**TWO NOTICES OF REQUIREMENT FOR THE  
TAKAANINI LEVEL CROSSING (TLC) PROJECT AND  
FOUR NOTICES OF REQUIREMENT FOR THE SOUTH  
FREQUENT TRANSIT NETWORK (FTN) PROJECT**

**HEARING REPORT – VOLUME ONE**

**NOR 1 TAKAANINI LEVEL CROSSINGS (TLC)  
– SPARTAN ROAD, MANUIA ROAD, MANUROA  
ROAD AND TAKA STREET**

**NOR 2 TAKAANINI LEVEL CROSSINGS (TLC)  
– WALTERS ROAD LEVEL CROSSING CLOSURE  
AND NEW MULTI-MODAL BRIDGE**

**Taka Street: modification sought:**

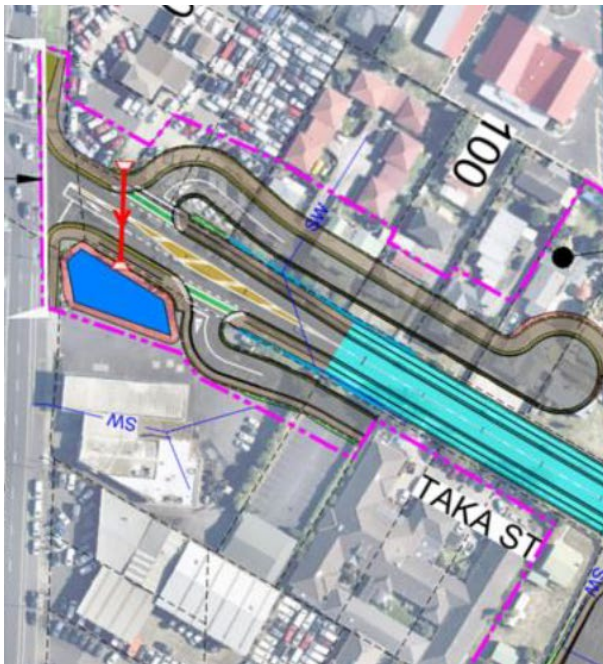
### **Modified NoR 1 boundary request – Taka Street project area (west)**

The letter advises that the Requiring Authority will address the full rationale for the proposed change and implications for the assessment of environmental effects will be addressed in evidence moving forward.

I consider it appropriate that the Requiring Authority provides the following information either in evidence or at the hearing:

- address the full rationale for the proposed change and implications for the assessment of environmental effects for the altered extent of Takaanini Level Crossings Notice of Requirement – NoR 1-Taka Street Project Area (west) (as set out in Supporting Growth’s 9 November 2023 letter to council).

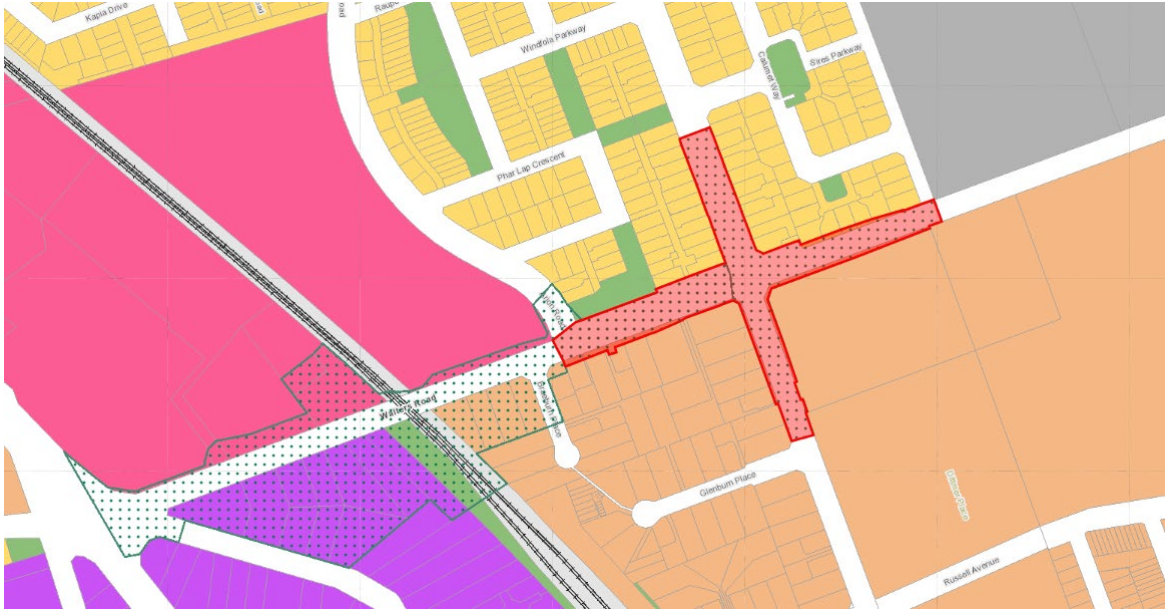
The potential cumulative effects of the overlapping NoRs have not been addressed in the AEE or supporting assessments for the South FTN NoRs.

The map below displays the South FTN: Great South Road FTN Upgrade NoR 1 designation area, shown in red outline, which includes upgrades on the corner of Great South Road and Taka Street. This overlaps with the Takaanini Level Crossing NoR 1 designation (Taka Street project area) shown in green dots on the map below.

Figure 3: Aerial view of Takaanini Reserve

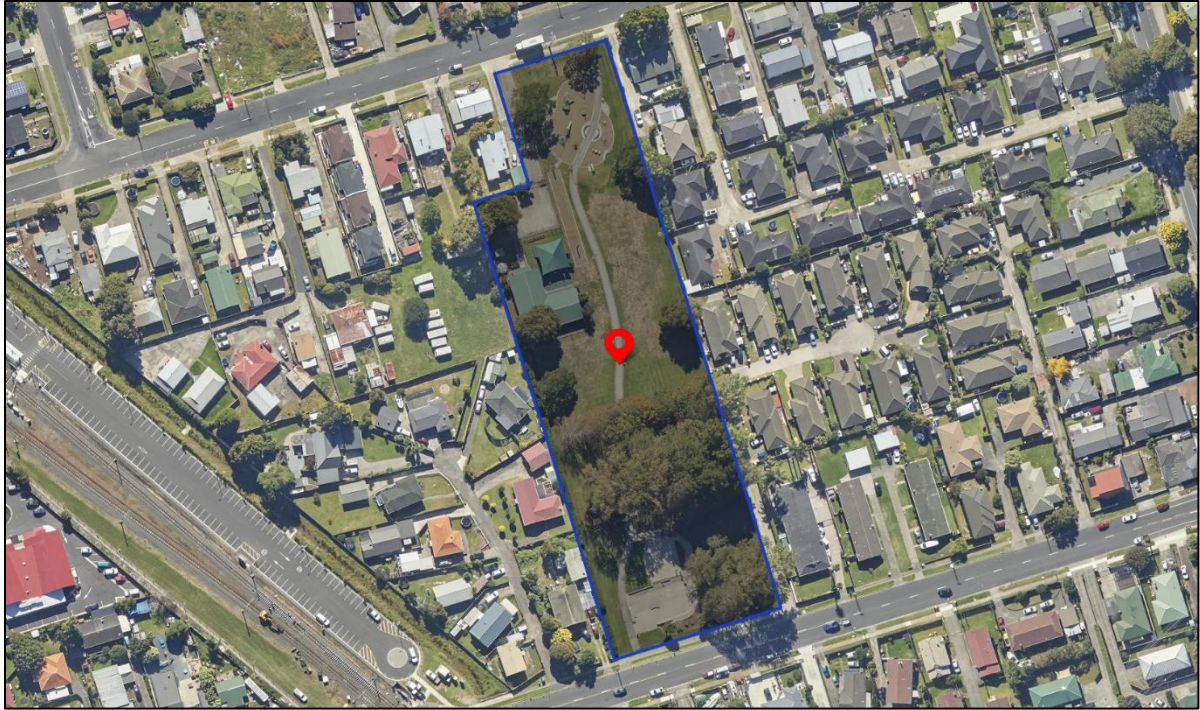
4.10. This reserve, shown Figure 3, is affected by NoR 1 only. The reserve is known interchangeably as 'Taka' or 'Takanini' or 'Takaanini' Reserve. For the purposes of this document, it will be referred to as 'Takaanini Reserve'. The reserve is mainly a rectangular parcel of land extending from Station Road to Taka Street. The site is zoned Open Space - Informal Recreation Zone under the AUP(OP).

Figure 4: Opportunities and constraints diagram from Urban Design Evaluation report

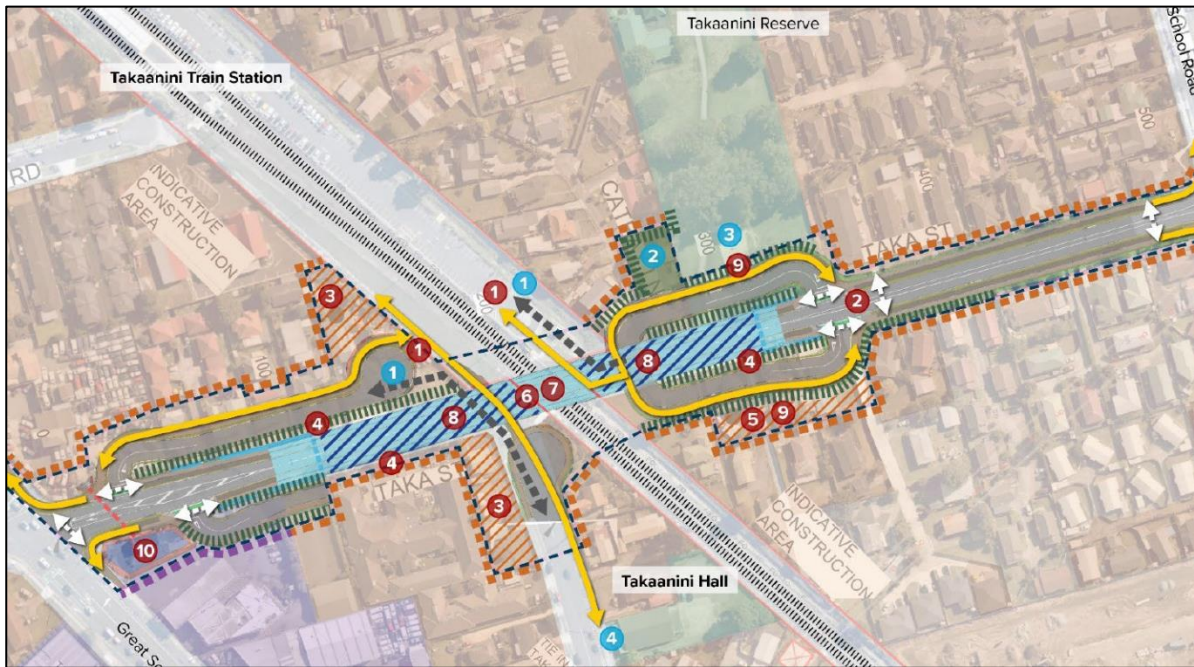
4.13. The submitted General Arrangement Plans and Form 18 Plans show that about 1400m<sup>2</sup> of land will be taken from Takaanini Reserve – the current area of this reserve is 1.592Ha (12% land take). This is required to make space for a new traffic bridge and revised access areas for private properties. The Urban Design Evaluation shows that there are opportunities for new landscaping along the new road frontage of the reserve. Figure 4 provides a visual explanation.

4.25. The General Arrangement Plans and Urban Design Evaluation show that Takaanini Reserve will be extended to the west (see Figure 4), with about 500m<sup>2</sup> being incorporated into the park, and that connections can be made to Takaanini Railway Station. When accounting for the estimated 1400m<sup>2</sup> of land take along the park's frontage, there would still be a net loss of 900m<sup>2</sup> (7% reduction of park size)

Figure 6: Opportunities and constraints diagram from Urban Design Evaluation report

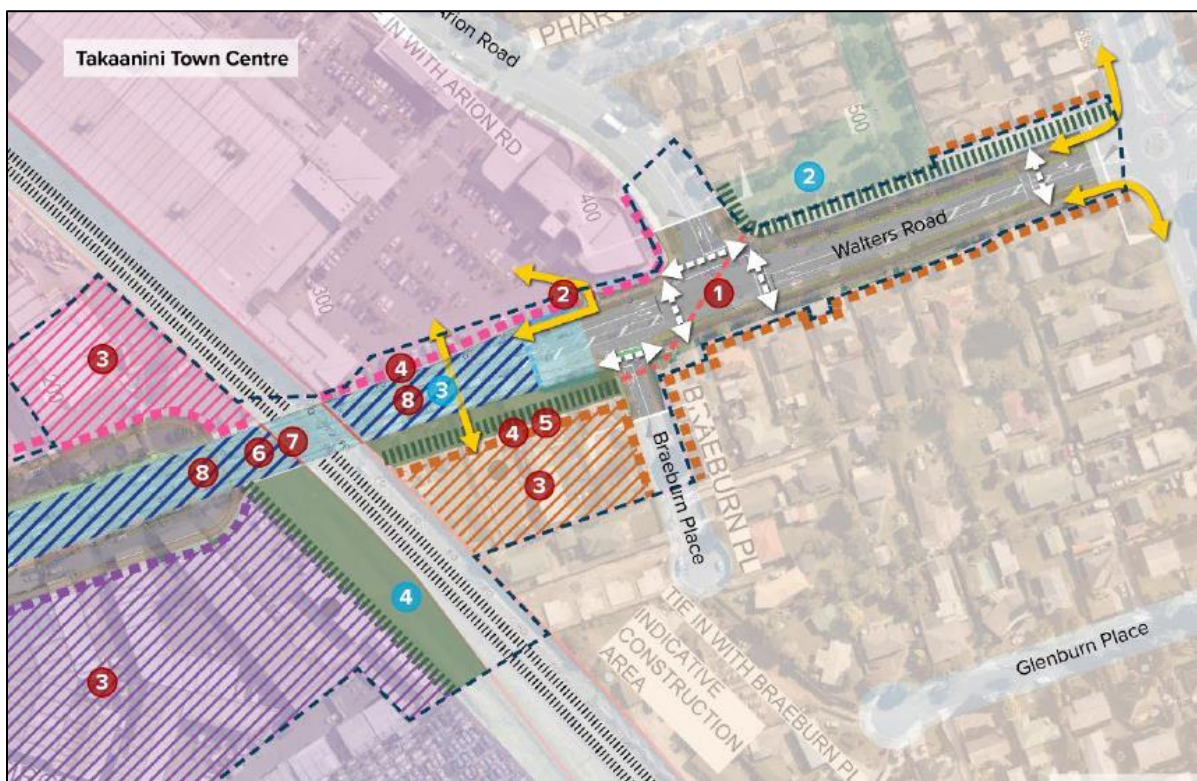
4.18. The submitted General Arrangement Plans and Form 18 Plans show that about 1900m<sup>2</sup> of land will be taken from Walters Accessway and about 50m<sup>2</sup> from Arion Reserve. This is required to make space for a new traffic bridge, revised access areas for private properties, and to increase the size of the intersection of Arion and Walters Roads. Figure 6 provides a visual explanation and indicates that landscaped edges are a potential opportunity in relation to these reserves.

Figure 9: Excerpt from POSNP indicating a gap in neighbourhood parks in Takanini. Aqua outline inserted to show the approximate project area.

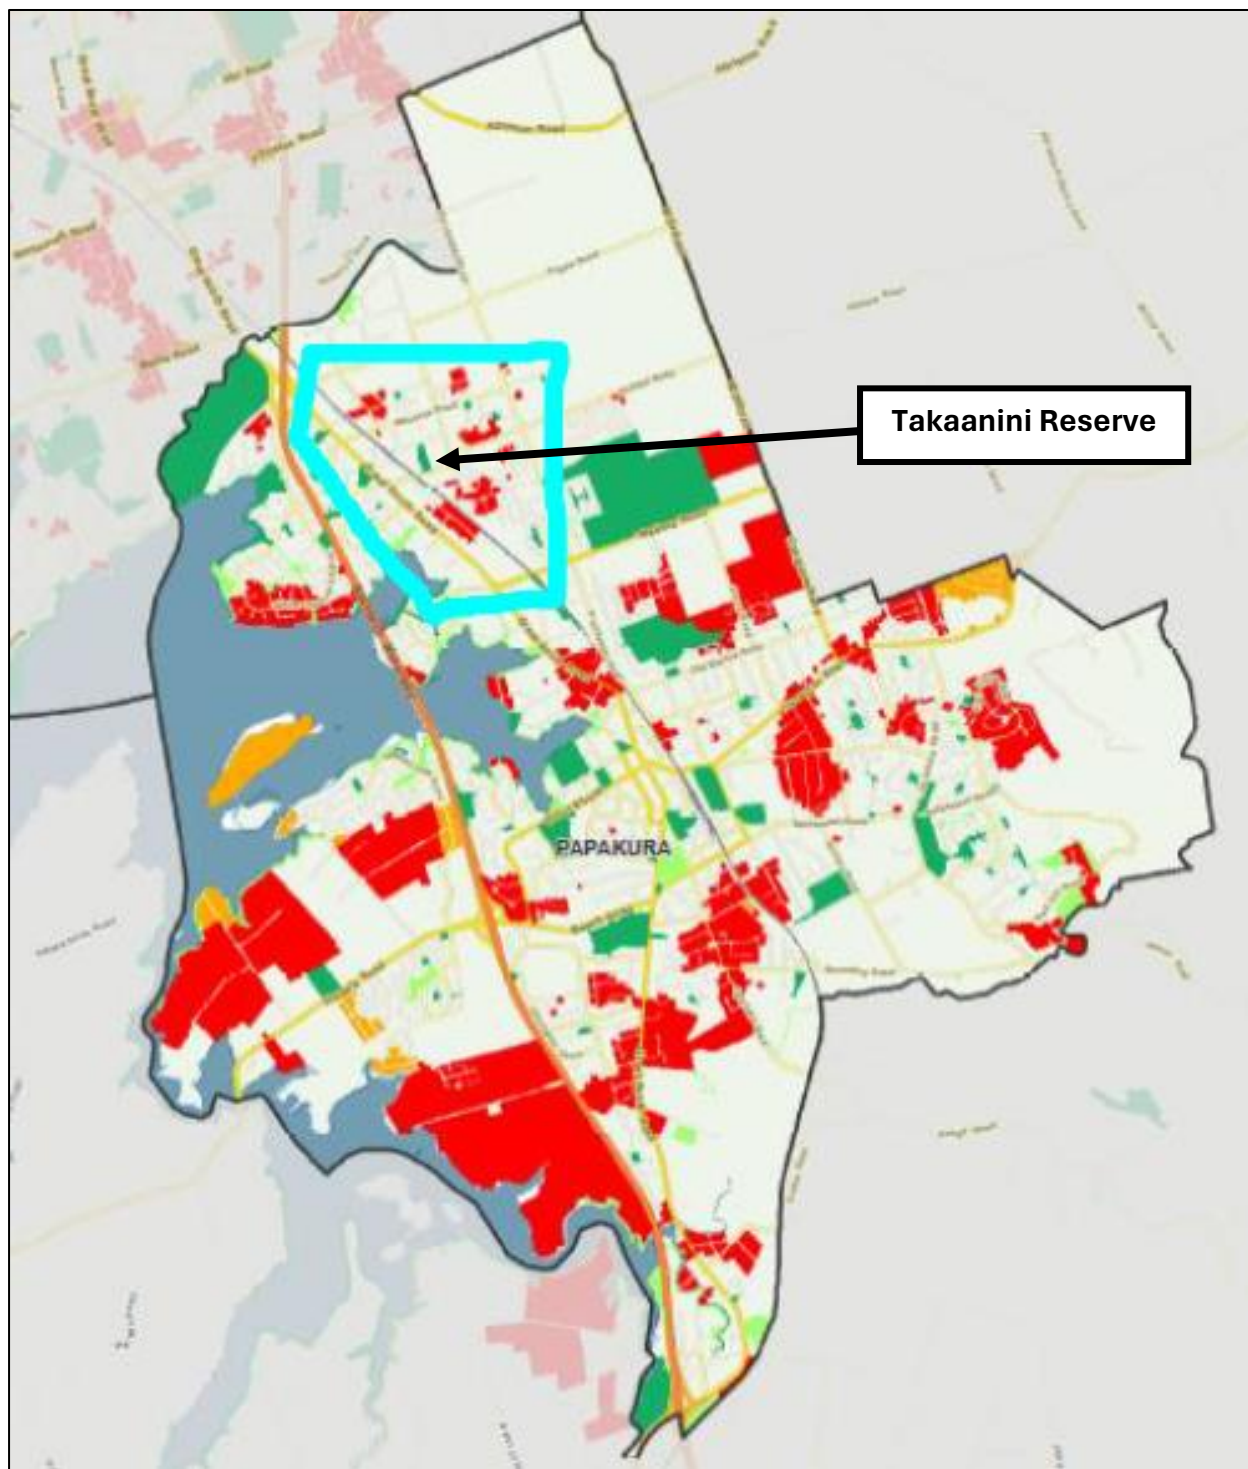
4.48. A matter of note is that the POSNP identifies that there is a 'gap' within the open space network for 'neighbourhood parks' around Takanini. The POSNP includes a diagram explaining this gap – see Figure 9 below. The POSNP explains that 'neighbourhood parks'<sup>7</sup> are usually around 0.3 – 0.5 Hectares in size. This gap initially suggests that the loss of open space land from Takaanini Reserve could worsen the situation.

Figure 1 - Manuroa Road turning head east of level crossing

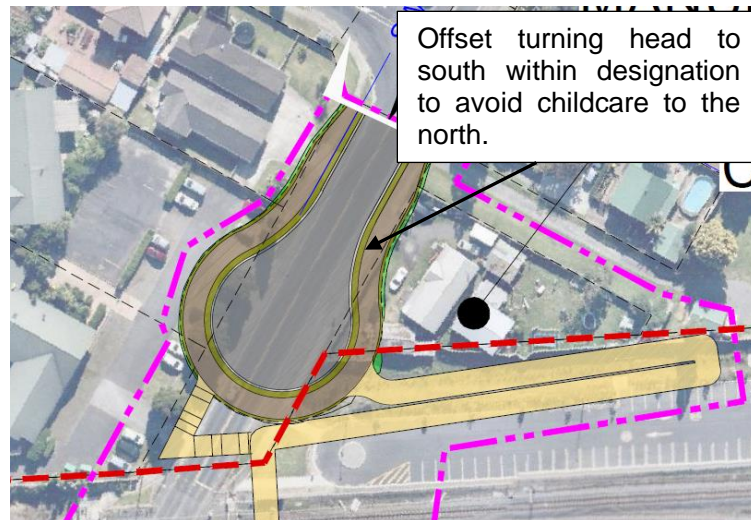
- 4.5.25. The turning head on the eastern side of the level crossing has been designed so it is central to Manuroa Road and affects the car parking area within the childcare centre at 18 Manuroa Road (refer Figure 1). The design of the turning head was questioned in a s92 Request for Further Information<sup>8</sup> to determine whether the turning head could be redesigned to avoid the property and be offset to the south. The response referred to the Assessment of Alternatives. However, this issue is only dealt with in broad terms and not the specifics of this location. In my view the turning head could be redesigned to avoid, or at least minimise the effects on the parking for the child care centre within

- 4.5.26. I recommend that the applicant either in evidence or at the hearing demonstrates that it is reasonably necessary to position the turning head within 18 Manuroa Road rather than designing it with an offset to the south.

Figure 2 - Manuroa Road Turning Head (east side) with asymmetrical turning head overlaid

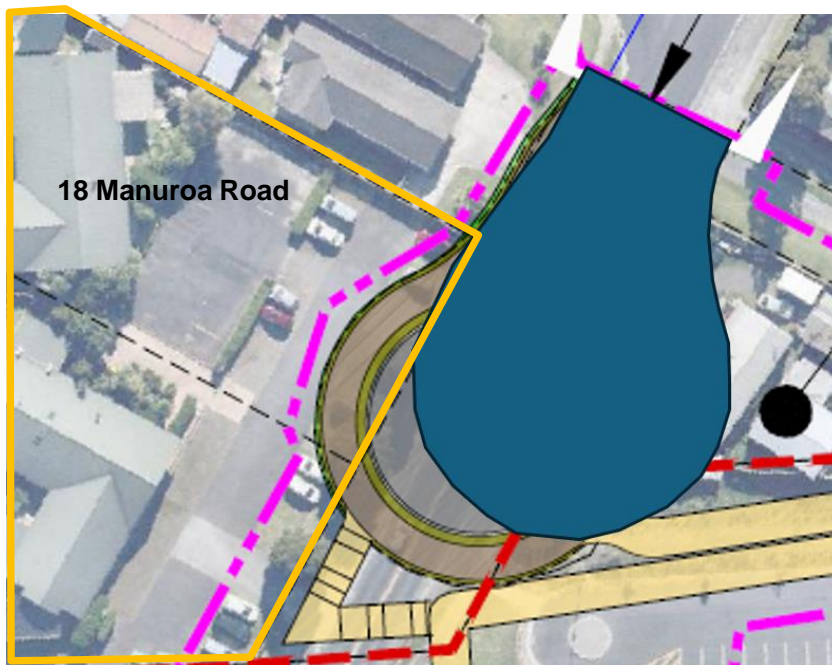
- 5.9.8. It is recommended that the Requiring Authority examine the option to design the turning head asymmetrically so it extends to the south of Manuroa Road and remove or at least reduce the proposed designation boundary from the submitters site.

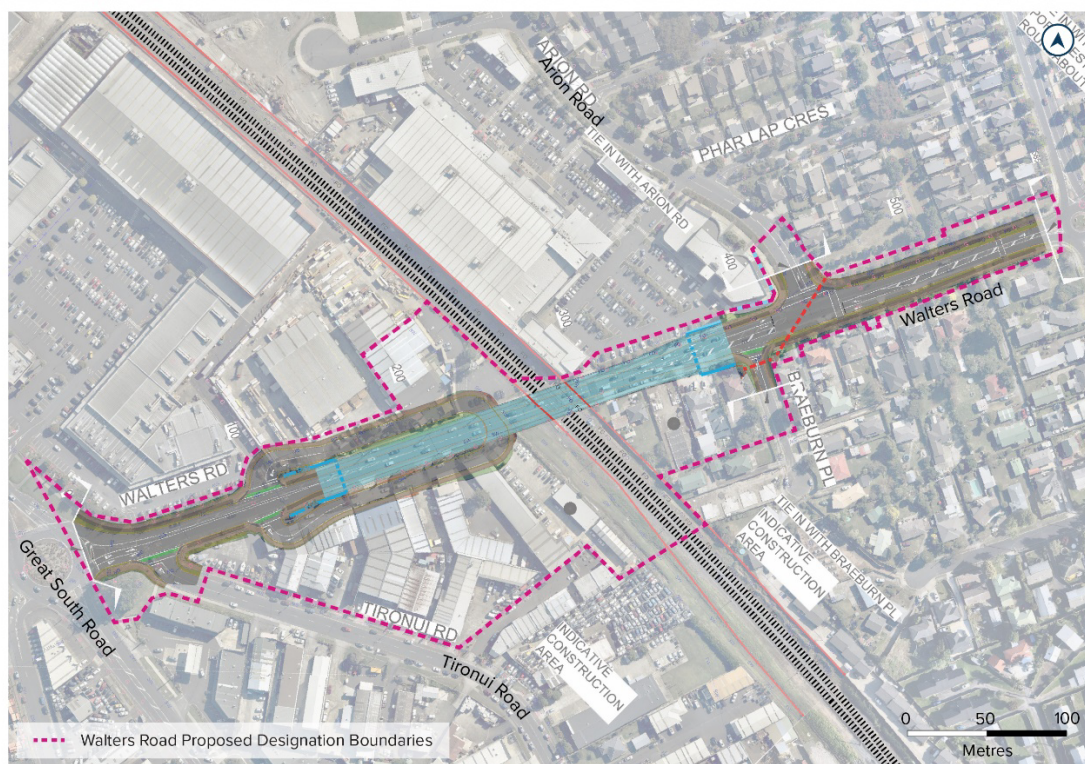
4.5.7 In conclusion, the assessment of the proposed development project along Taka Street reveals a range of considerations and recommendations across various principles of urban design and environmental sustainability. While there are positive aspects to the proposal, such as the potential for future tree planting and naturalized stormwater treatment, several key concerns have been identified. These include the loss of mature trees impacting ecological corridors and biodiversity, the adverse effects on social cohesion and sense of place due to the scale and massing of the proposed structures, and potential compromise to pedestrian and cyclist safety due to the design of some connections.

4.5.8 Additionally, the assessment raises doubts about the ability of the proposal to align with density, scale appropriately with the surrounding urban context, and facilitate an appropriate interface between place and movement. Concerns also extend to the impact on local businesses, access to employment and industry, and the legibility of corridor function. While some recommendations for future design stages are acknowledged, such as the need for landscape responses and improved active mode connectivity, the overall conclusion suggests that the current proposal falls short of meeting the desired outcomes for several urban design principles.

4.5.9 In light of these findings, it is imperative that future design stages carefully address the identified shortcomings and prioritize solutions that better align with the principles of social cohesion, and urban livability.
